Access Compliance Report Public Rights-of-Way (Curb Ramps)

Intersection ID: 10033070 Main Street: NORTH_COMMUNITY_HOUSE_RDss Street: N/A Location: NW

ADA ID: EAA6D4DE15CA Ramp Type: Perp Initial Pass/Fail: Fail Overall Compliance: No Severity Score: 13.75

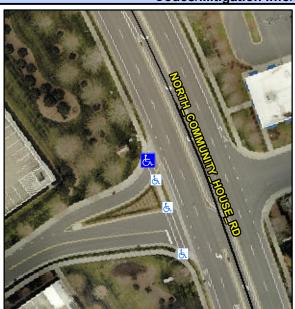
Not Found, R304.2.2, R304.5.3

Field Measurements/Component Compnance					
Compliance Description		Data	Compliance Description		Data
N/A	Ramp Length (in)	60.0	No	Ramp Slope (%)	9.2
Yes	Ramp Width (in)	62.0	No	Ramp XSlope (%)	3.5
N/A	Flare Type LT	N/A	N/A	Flare Type RT	N/A
N/A	Flare Slope LT (%)	N/A	N/A	Flare Slope RT (%)	N/A
N/A	Flare Traversable LT?	N/A	N/A	Flare Traversable RT?	N/A
N/A	Landing Length (in)	N/A	N/A	DWS Provided?	N/A
N/A	Landing Width (in)	N/A	N/A	DWS Contrast?	N/A
N/A	Landing Slope (%)	N/A	N/A	DWS Length (in)	N/A
N/A	Landing X Slope (%)	N/A	N/A	DWS Full Width?	N/A
N/A	Landing Curb? (Y/N)	N/A	N/A	DWS Offset (in)	N/A
N/A	Shared Landing?	N/A			
N/A	Gutter Ponding?	N/A	N/A	Gutter Slope (%)	N/A
N/A	Gutter Lip Ht (in)	N/A	N/A	Gutter X Slope (%)	N/A
N/A	Painted X Walk1?	Yes	N/A	Painted X Walk2?	N/A
	X Walk 1 Direction	To SE		X Walk 2 Direction	N/A
N/A	X Walk 1 Width (in)	76.0	N/A	X Walk 2 Width (in)	N/A
	X Walk 1 Slope (%)	4.6		X Walk 2 Slope (%)	N/A

Remove & Replace Entire Ramp.
